SERVICE BULLETIN

Service Bulletin No.: DA20-74-01 Rev 0

Title: Activation of an Advanced Start Module

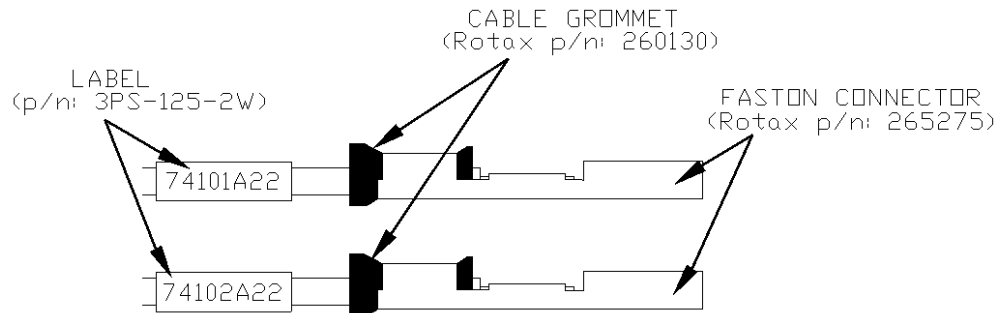
- 11.1. Remove engine cowls.
- 11.2. Disconnect the battery. Refer to AMM, Chapter 24-31.
- 11.3. Prepare two wires (p/n: M22759-16-22-9) each 1200mm long.
- 11.4. Record wire code 74101A22 on two labels provided (3PS-125-2W), apply and shrink onto each end of one wire. Repeat process with second wire and wire code 74102A22. See schematic below for reference.

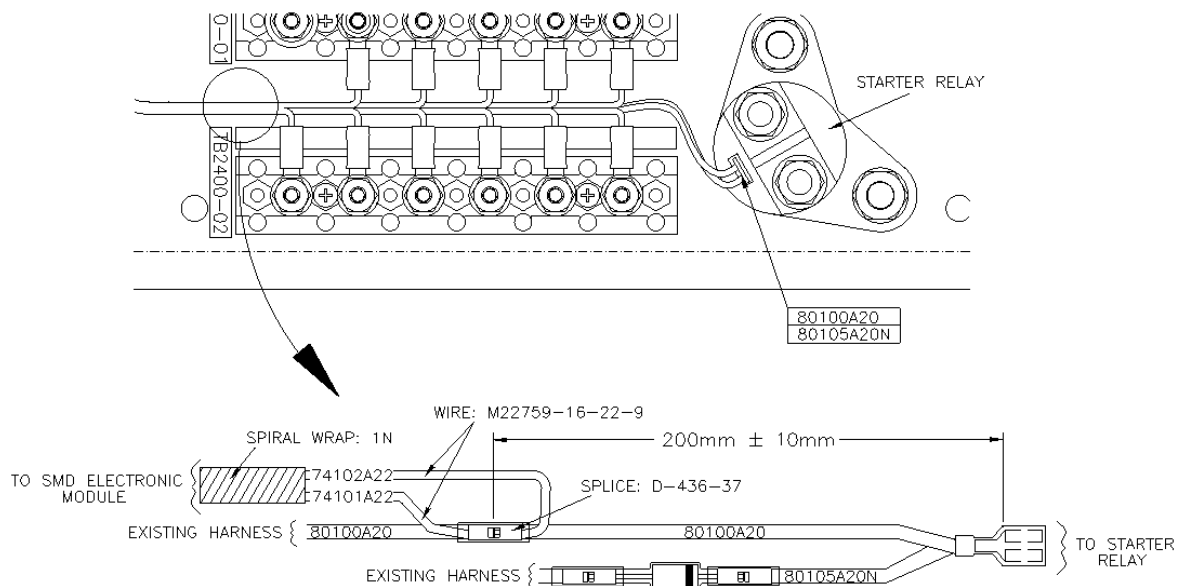
- 11.6. Remove the rubber plug from the engine harness side of the 6-pin connectors located at the SMD electronic modules (circuit A and B) and insert the faston crimped wires. Refer to ROTAX Service Instruction SI-912-020, Section 74-00-00 Subsection 1.
- 11.7. Install spiral wrap (p/n: 1N) around both wires.
- 11.8. Route wires along existing harness to junction box located on firewall.
- 11.9. Cut existing 80100A20 wire at 200mm from STARTER relay.
- 11.10. Cut 74101A22 and 74102A22 wires to required length and splice (p/n: D-436-37) into 80100A20 wire. See below.

NOTE: Ensure wire code labels are not removed when wires 74101A22 and 74102A22 are cut to length.
